Corrections of Hardware Manual

MB90495

Addendum, MB90495G Hardware Manual (hm90495-cm44-10114-3e)

This is the Addendum for the Hardware Manual hm90495-cm44-10114-3e of the MB90495G microcontroller series. It describes all known discrepancies of the MB90495G microcontroller series Hardware Manual.

Power On : Port behaviour

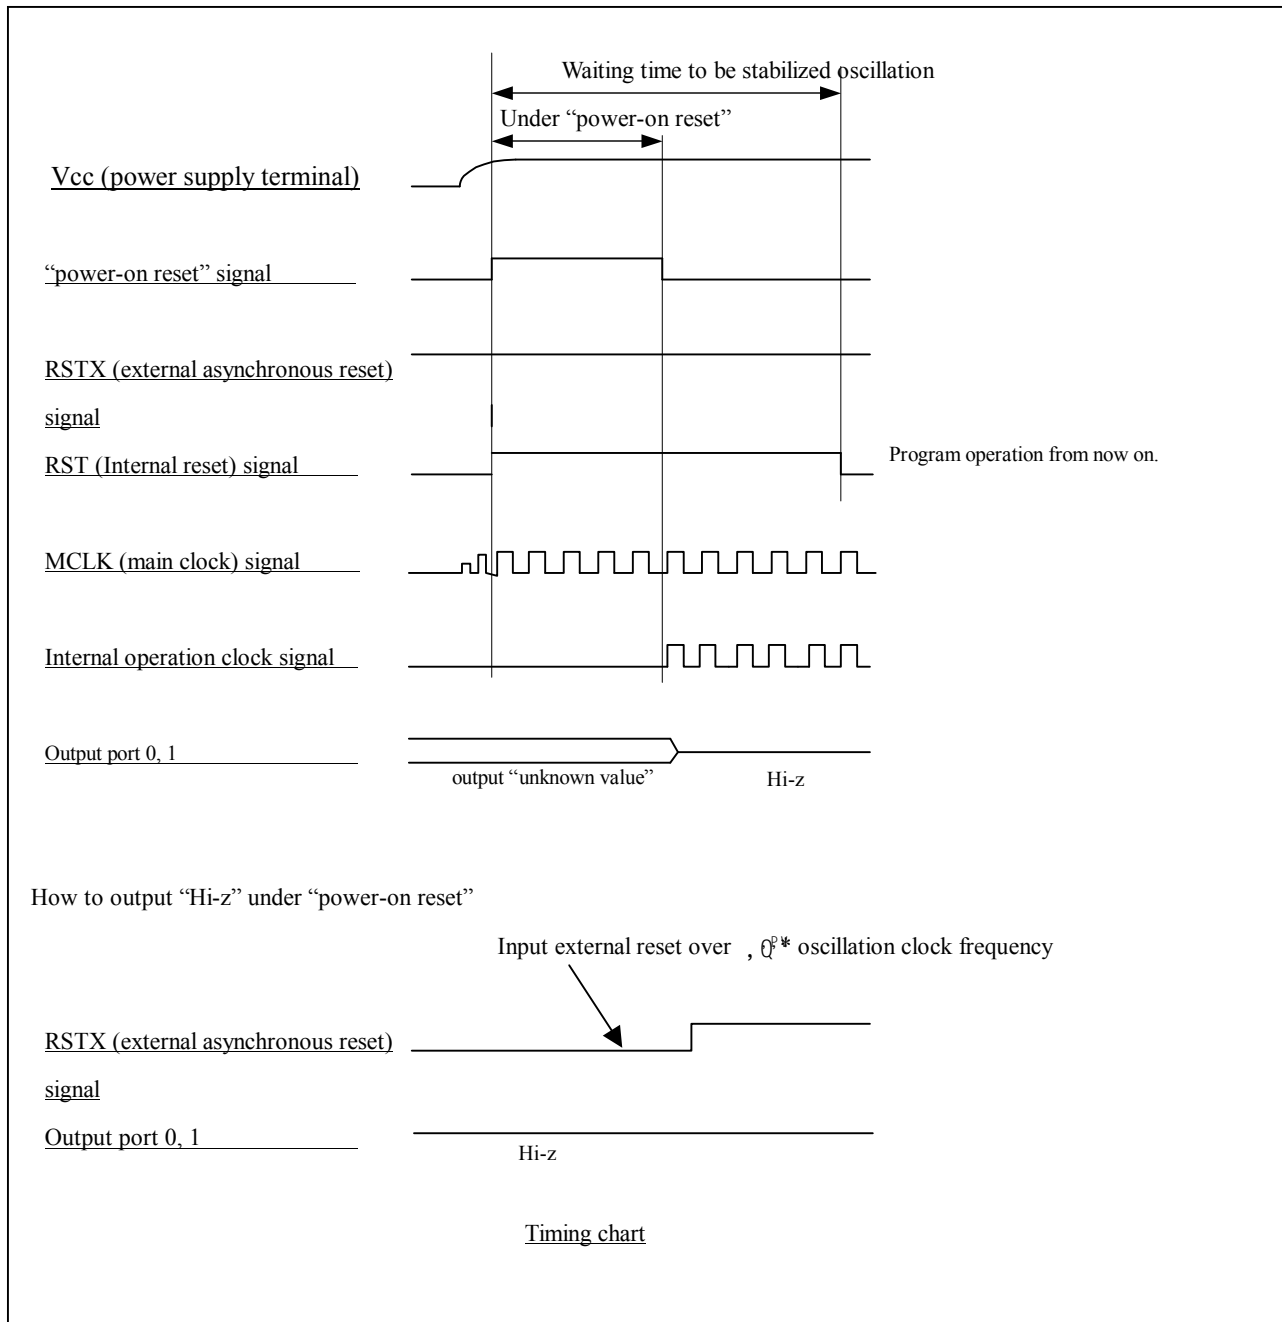
When the external reset, RSTX, is not asserted during Power On, pins on port 0 and 1 will be in an undefined state. Pins on port 2, 3, 4, 5 and 6 enter High-Z upon Power on reset.

To make sure that all ports are High-Z, the external reset RSTX must be kept asserted for the entire power on reset period.

If the external reset gets disasserted during the power on reset period, the pins on port 0 and 1 will become undefined.

Pin 00 to pin 07 and pin 10 to pin 17 terminal become "unknown value" (output "H", "L" level or output "Hi-z") under "power-on reset" (stabilized times (2^{\square} * oscillation clock frequency) of clamping circuit for internal power supply), when the power supply is turned on, and when "power-on reset" function operates and RSTX terminal is "H" level.

If you want to output "Hi-z" under "power-on reset", it is applied reset input "L" level " from external and so pin 00 to pin 07 and pin 10 to pin 17 terminal become "Hi-z" condition during the time.

This workaround will work for Mode pin setting 011 (Single chip, Internal ROM external bus), 110 (Burn_In ROM), 111 (EPROM mode)

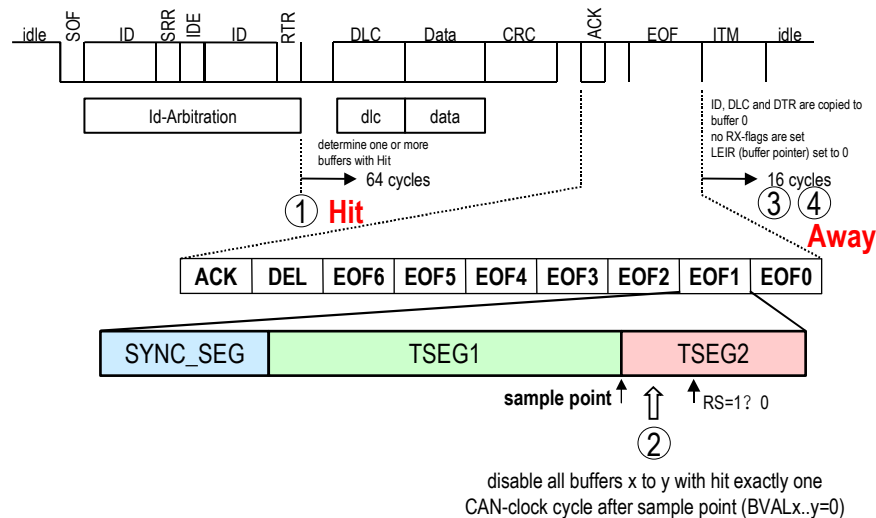
If there is a complete (no error until 6th bit of EOF) incoming message that have passed the acceptance filter, then this message is stored into a message buffer x (with x=0...15). If this store operation coincides with reset operation of the corresponding BVAL bit (BVALx=0), the received message will be stored into the message buffer 0 regardless of register settings. Note that this coincidence has to happen within a specific CAN-clock cycle (see event 2 in figures). Hence, the probability is very low.

When disabling message buffers by the BVAL register, it must be avoided that the write operation to the BVAL register coincides with the store operation of the received message in the CAN Controller.

The following diagram illustrates the timing to be avoided for the BVAL write operation.

- ① CAN-controller determines buffers, which can store the message, because their acceptance filters had been passed.
- ② Software disable all buffers with hit exactly one CAN-clock cycle after the sample point of EOF1.
- ③ CAN-controller stores received ID, DLC and data in buffer 0 regardless of the buffers determined in ①.
- ④ CAN-Controller sets LEIR to point to buffer 0 but RX-flags (RCR, ROVR, RRTRR) are not set.
- ④

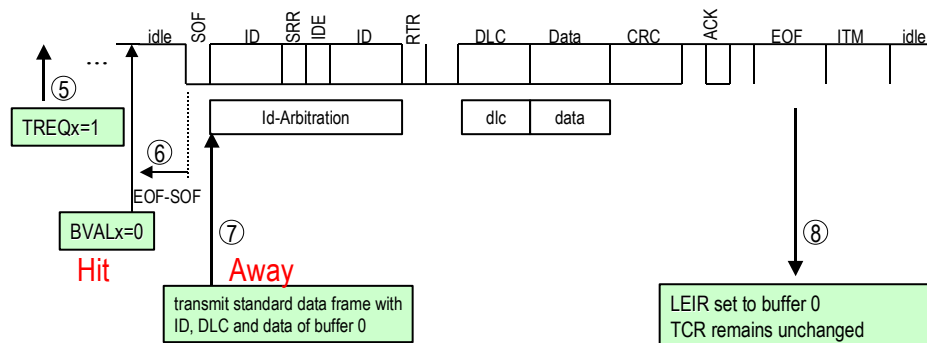
When there is a pending transmission of buffer x and the CAN bus status is in Intermission or in Bus Idle, the CAN-controller will load the message from buffer x in order to send it. If this load operation coincides with disabling the pending message buffer x by clearing the BVAL bit, this results in transmission of a Standard message. This message consists of RTR=0, IDE=0, DLC, 11 ID bits and Data stored in the message buffer 0. Note that this coincidence has to happen with in a specific CAN-clock cycle. Hence, the probability is very low. The position of that cycle depends also on previous frame reception and occurrence of error frames.

When disabling message buffers by the BVAL register, it must be avoided that the write operation to the BVAL register coincides with the preparation for the next transmission in the CAN Controller.

The following diagram illustrates the timing to be avoided for the BVAL write operation.

- ⑤ Software requests transmission of buffer x by setting TREQx.
- ⑥ Software disables the buffer x by clearing BVALx.
- ⑦ CAN-controller transmits a standard data frame with ID, length code and data of buffer 0.
- ⑧ After completion of frame only LEIR is updated for buffer 0. However, TCR is not set (neither for buffer 0 nor for buffer x).
